Land Development Regulations
Major Development Application
Major Development
Submittal Review Comments No. 4 – REVISION 1

Permit No.: **PZ23-0008**

Project Name: **SUBMITTAL NO. 4 REVIEW – REVISION 1
PROPOSED COMMERCIAL DEVELOPMENT
METAL ROLL FORMING COMMERCIAL FACILITY
25870-000-000: 909 WEST STREET, PARKER, FLORIDA 32404
25869-000-000: 4623 EAST 2ND STREET, PARKER, FLORIDA 32404
25838-000-000: 4610 EAST HIGHWAY 98 BUSINESS**

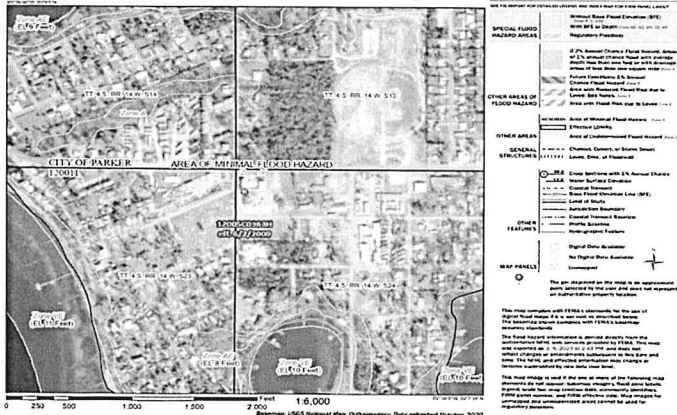
CITY COMMENT 01/26/24: A revised Site Plan was submitted on 01/23/24 which included an updated Site Data table. With the information provided, the following lot coverage has been calculated:

Impervious Surface	Size in SF
Building	28,000
Pavement/Parking	12,787
Sidewalks	1,128
Heavy-Duty Asphalt	7,297
Gravel	1,484
Stormwater Ponds	5,136
Total	55,832

Lot Coverage = Impervious Surfaces (SF)/Lot Area (SF)
Lot Coverage = 55,832 SF/125,017 SF = 44.65%

It should be noted that Lot Coverage is not denoted on the plan set. As a conditional approval, please add the Lot Coverage of 44.65% under the Site Data Table in the final signed and sealed plan set.
